<b>Title - Sujet</b> FLATBED TRUCKS WITH CRANE	
<b>Solicitation No. - N° de l'invitation</b> F2519-160015/A	<b>Amendment No. - N° modif.</b> 002
<b>Client Reference No. - N° de référence du client</b> F2519-160015	<b>Date</b> 2016-11-28
<b>GETS Reference No. - N° de référence de SEAG</b> PW-\$\$HP-923-71784	
<b>File No. - N° de dossier</b> hp923.F2519-160015	<b>CCC No./N° CCC - FMS No./N° VME</b>
<b>Solicitation Closes - L'invitation prend fin at - à 02:00 PM on - le 2016-12-16</b>	<b>Time Zone</b> Fuseau horaire Eastern Standard Time EST
<b>F.O.B. - F.A.B.</b> <b>Plant-Usine:</b> <input type="checkbox"/> <b>Destination:</b> <input checked="" type="checkbox"/> <b>Other-Autre:</b> <input type="checkbox"/>	
<b>Address Enquiries to: - Adresser toutes questions à:</b> Martin, Erik	<b>Buyer Id - Id de l'acheteur</b> hp923
<b>Telephone No. - N° de téléphone</b> (873) 469-3318 ( )	<b>FAX No. - N° de FAX</b> ( ) -

THIS SOLICITATION AMENDMENT **002** IS ISSUED TO POST QUESTIONS AND ANSWERS #1 TO #22 AND THE REVISED ANNEX A – SPECIFICATIONS – FLATBED TRUCKS WITH CRANE (REVISED NOVEMBER 23, 2016).

**Solicitation #F2519-160015/A**  
**Flatbed Trucks with crane - Questions & Answers**

Picture related to Answers #2 and #6

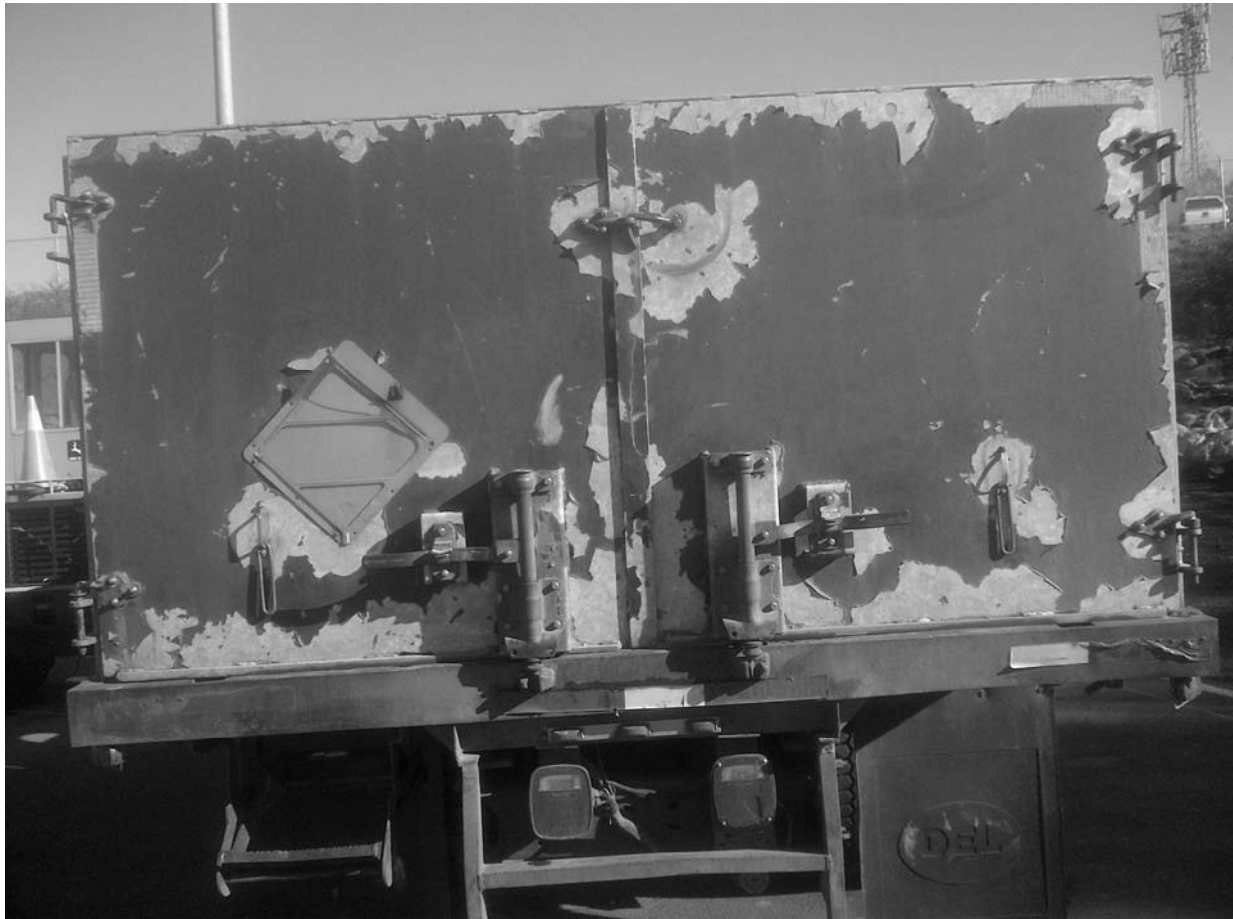
Q #	Questions in English	Answers in English	Modify Specs?
1	<b>Question:</b> I am checking to see if you would accept a 475 hp and 1700 ft tq. engine?	No. 500HP and above.	No
2	2.12 Crib area 2.12.2 Side and rear crib walls must be a minimum of 48" high, be removable and fabricated of aluminum. With swing open rear doors. All sections not to exceed 48" in length.  <b>Questions:</b> What is a crib wall? Is it what is normally called side racks? Since there is no aluminum side racks available on the market, could you provide pictures of an existing set up or a manufacture's part number for references? Do you need a spot to store the crib wall on the truck when the crib wall is not installed?	Please see attached photos for view of existing crib walls. When removed, crib walls do not require extra storage on the truck.	No
3	2.12.4 Must be located on passenger side of deck, between crib and rub rails.  <b>Questions:</b> What must be located on passenger side of deck? Do we refer to section 2.12.3 with the boxes are already under the deck frame mounted?	This section was deleted in our final version of the submission. Unsure as to why it is on the tender.	Yes  Removed 2.12.4 from specs.

Must not interfere with load securement. <b>Questions:</b> Same questions for section 2.12.5 and 2.12.6.	interfere with load securement.	
6	2.12.7 Must have rear aluminum doors with tie back hooks. All side panels must be aluminum and be removable. <b>Questions:</b> Do we refer to section 2.12.2? Is the crib panels the same as deck side racks? Please provide pictures samples or pictures of existing truck or manufacture for references .Could we have a solid post on each corner at the rear to hold the rear doors.	See attached photo of existing crib walls and doors. Cannot have solid posts affixed to the corners. Doors are hinged to crib walls.	No
7	2.12.8 Stowage mounts for two outrigger pads. <b>Question:</b> Can you please provide location?	So as not to interfere with the operation of the vehicle or installed components. Closer to the outriggers would be preferable.	No
8	2.13 Load securement. 2.13.2 Winches/ratchets, anchors/tie downs must be mounted on side of crib. Please explain. <b>Questions:</b> Same question as section 2.12.2.	Winches or ratchets must be mounted under side of box, see attached photos.	Yes
